## Design Review Subcommittee (DRSC)

**SUBJECT:** **Staff Waiver of a Minor Architectural Permit 21-278, SC Ranch Market Gazebo**, a request to consider a detached patio cover for use as an outdoor display area in conjunction with a market.

SW MAP 21-278, SC RANCH MARKET GAZEBO  
101 E. EL PORTAL

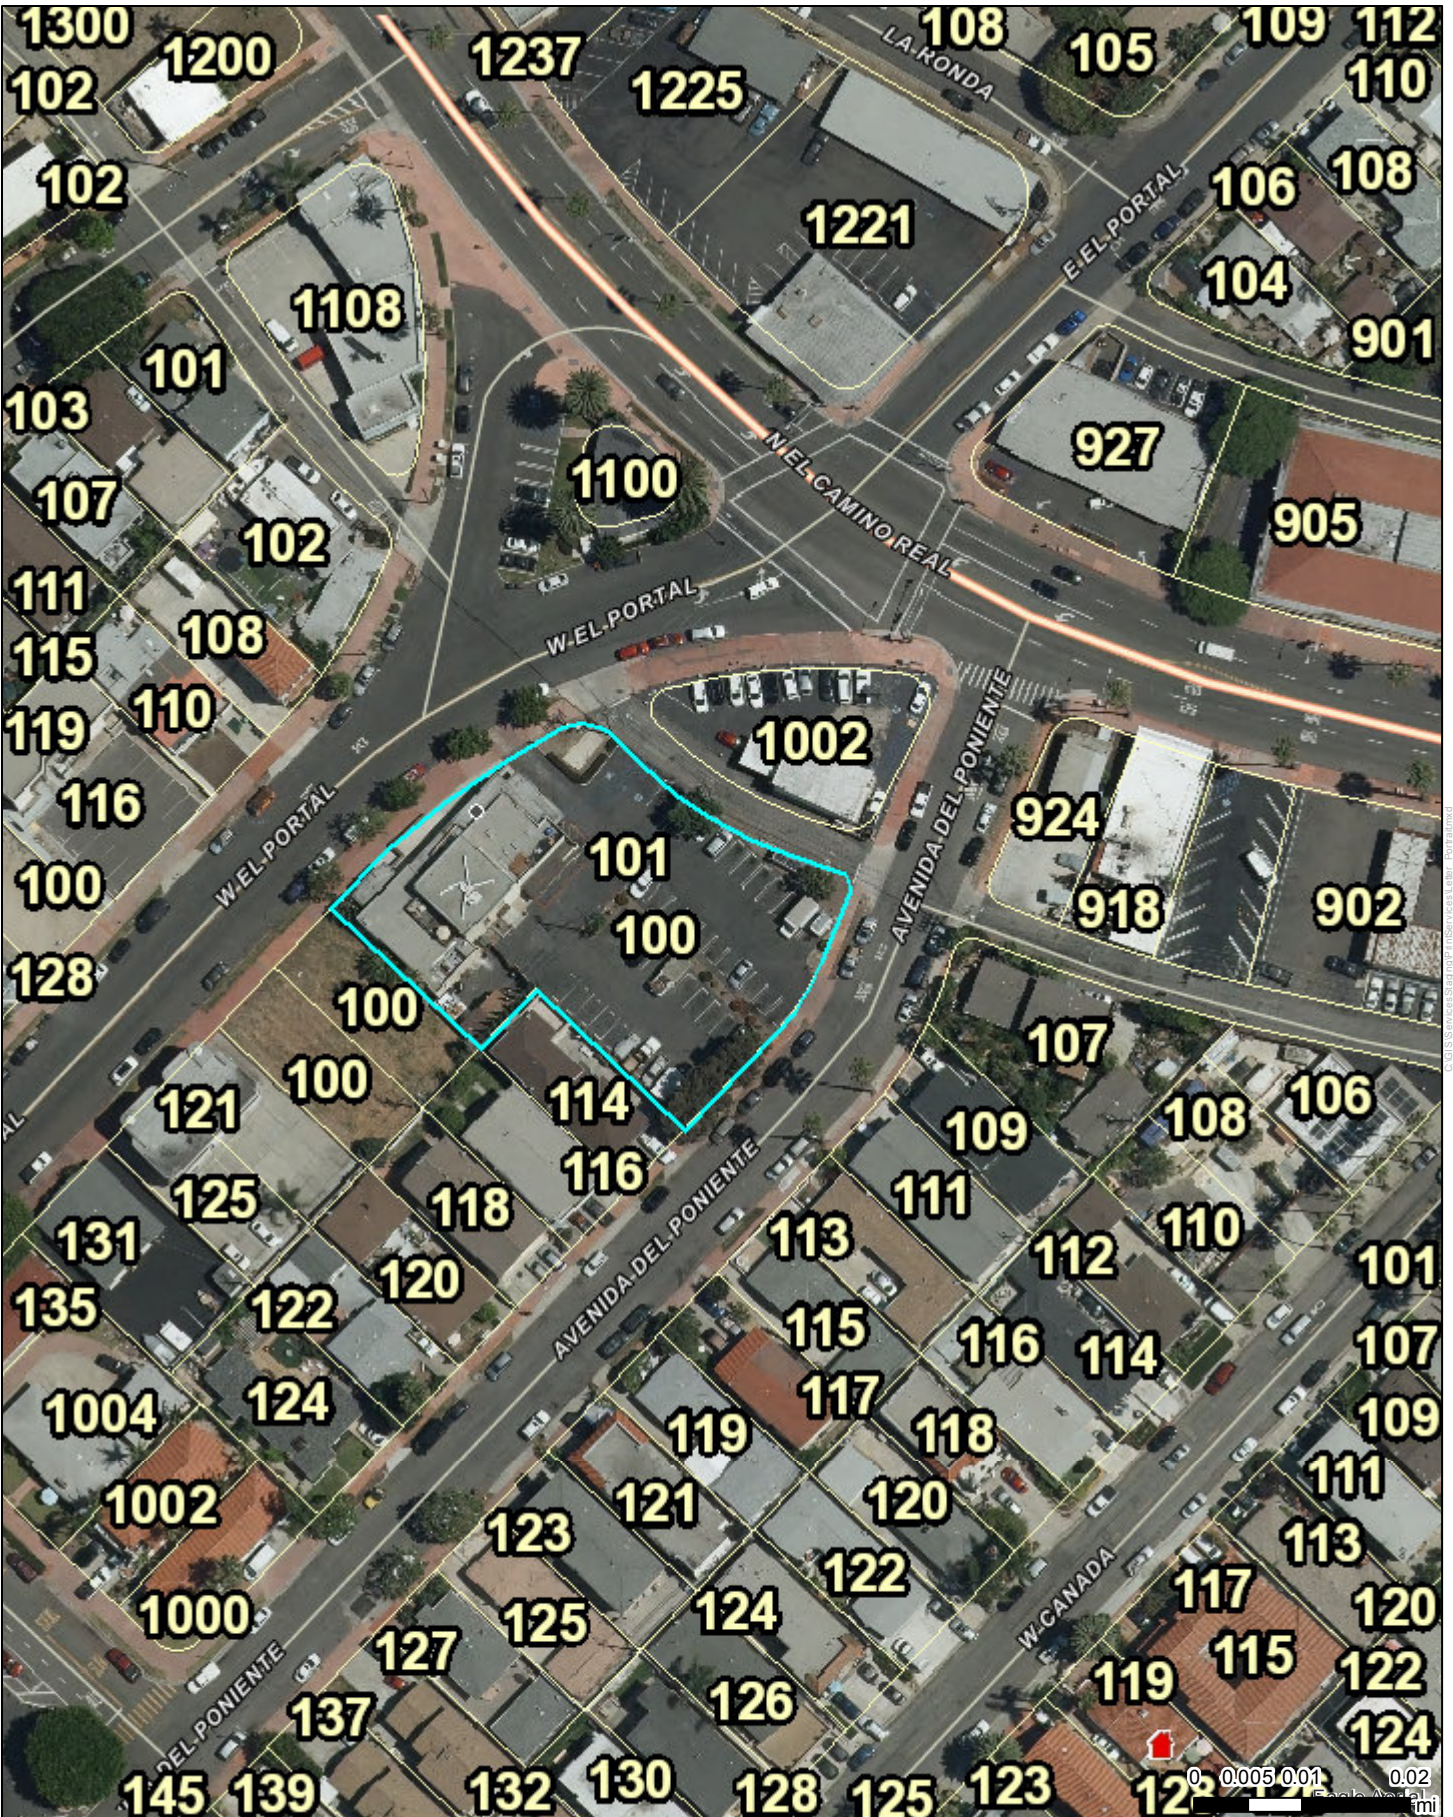
The patio cover was reviewed for compatibility with the surrounding neighborhood and with the primary commercial building on site where SC Ranch Market operates. The proposed patio cover is an improvement to the initial proposal submitted to the City in 2021. Image 3 below is the initial proposal.

Staff believes the proposed patio cover better complements the approved façade remodel (Attachment 4) for the market, and is consistent with surrounding development with regards to scale, massing, and design. The patio cover design matches the contemporary style of the primary building with it’s flat roof and mix of materials consisting of white and dark metal. However, due to previous concerns by the DRSC regarding the use of

corrugated metal on the detached patio cover and the property's location within a minor gateway, staff encourages the applicant to use an alternate material to secure the outdoor display area when the market closes. Additionally, for improved cohesiveness between the patio cover and the primary building, staff recommends that the proposed dark metal on the patio cover match the grey wood trim color on the primary building.

Staff is supportive of the overall design of the proposed patio cover. However, to improve consistency with the General Plan and Design Guidelines, staff recommends slight changes to materials and color. Staff also seeks feedback from the Design Review Subcommittee on an appropriate material to use to secure the patio cover when the market is closed.

1. Use an alternate material to secure the outdoor display area when the market closes.
2. Use a dark grey color on the proposed metal to match the trim color of the primary building.
